Product Change Notification / GBNG-25SJB110

CCB 4271 Initial Notice: Qualification of GTK as a new assembly site for selected AT28BV64Bxx, AT28C64Bxx and AT28HC64Bxx Atmel device families available in 28L SOIC (300mils) package.

PCN #: GBNG-25SJJB110

PRE-CHANGE / LPI

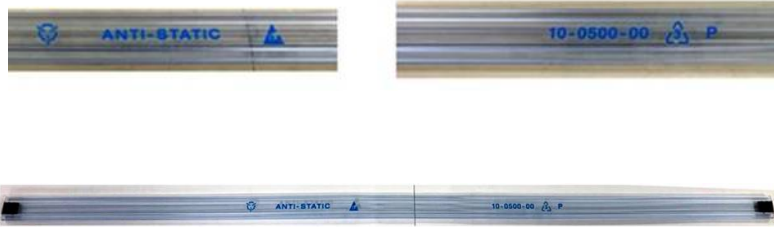
Package	Lead Count	Body Size	Units/ Tube	Length (inch)	End Plugs
SOIC	28	300 mils	27	20+/-0.10	Black/Black

POST-CHANGE / GTK

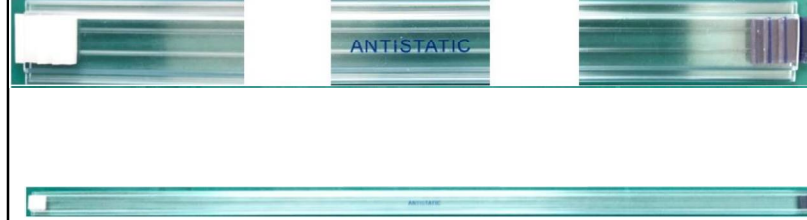
Package	Lead Count	Body Size	Units/ Tube	Length (inch)	End Plugs
SOIC	28	300 mils	27	20 +/- 0.05	Blue/White
